**Ref No.: BD-CW-SAMCO-ACE-LET-STR-063**

**Project Name:** The Big Business District.

**Contract/Package:** Construction Works of the Civil Works for Buildings B1, B2, B3 and B4 – Phase 1.

**Subject:** Comparison of the design issued on 18/03/2026 with the previous design issued on 27/10/2025.

## COLUMNS AND AXES LAYOUT-PART 1

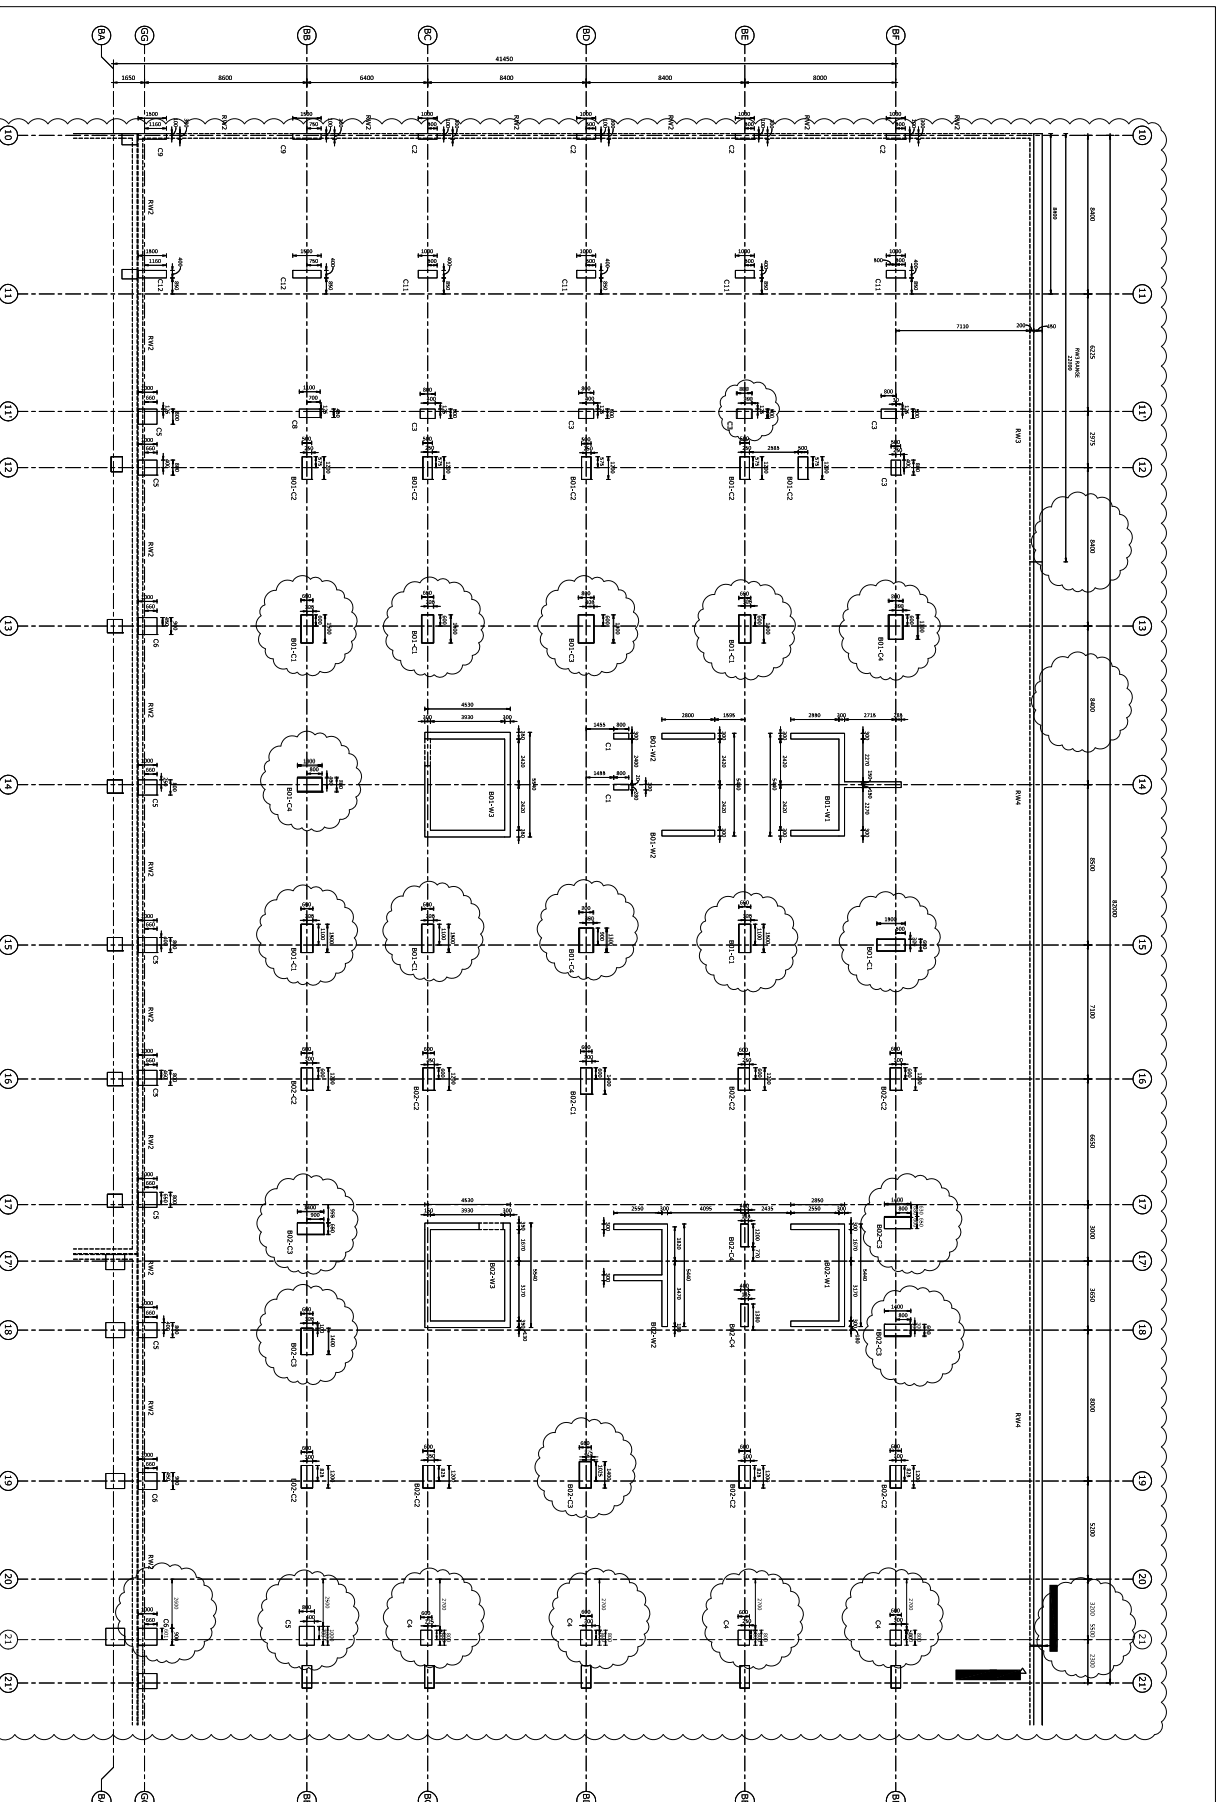
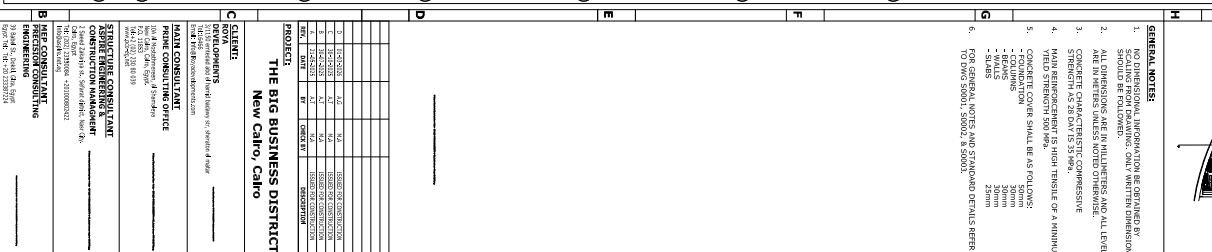
**1) Differences in grid and column layout drawings**

The project grid and column layout differ from the previously issued and approved drawings, which were executed accordingly. This affects the raft foundation and other related structural elements. For example:

**First: Columns of Building B1**

- Column (B01-C1) was executed with a width of 600 mm, Meanwhile, in the new design 650 mm
- Column (B01-C3) was executed with a width of 800 mm, Meanwhile, in the new design 850 mm
- Column (B01-C4) was executed with a width of 700 mm, Meanwhile, in the new design 800 mm

**Second: Columns of Building B2**

- Column (B02-C3) was executed with a width of 600 mm, Meanwhile, in the new design 650 mm
- Columns (C4, C5, C6): differences in column locations were found due to grid modifications

**Third: Columns of Building B3**

- Column (B03-C3) was executed with a width of 500 mm, Meanwhile, in the new design 550 mm
- Column (B03-C2): difference in location due to grid changes

**Fourth: Columns of Building B4**

- Column (B04-C1) was executed with a width of 600 mm, Meanwhile, in the new design 650 mm
- Column (B04-C5) was executed with a width of 700 mm, Meanwhile, in the new design 750 mm

Differences were found in grid locations (23–21') compared to the approved design, for which an RFI had previously been issued and officially approved:  
Attachment: BD-CW-SAMCO-PCO-RFI-STR-002-R01

For Grid Line 21', Please stick to drawing No. (SI000-COLUMN AND AXIS -OVERALL) issued via Strucure package on 27/10/2025
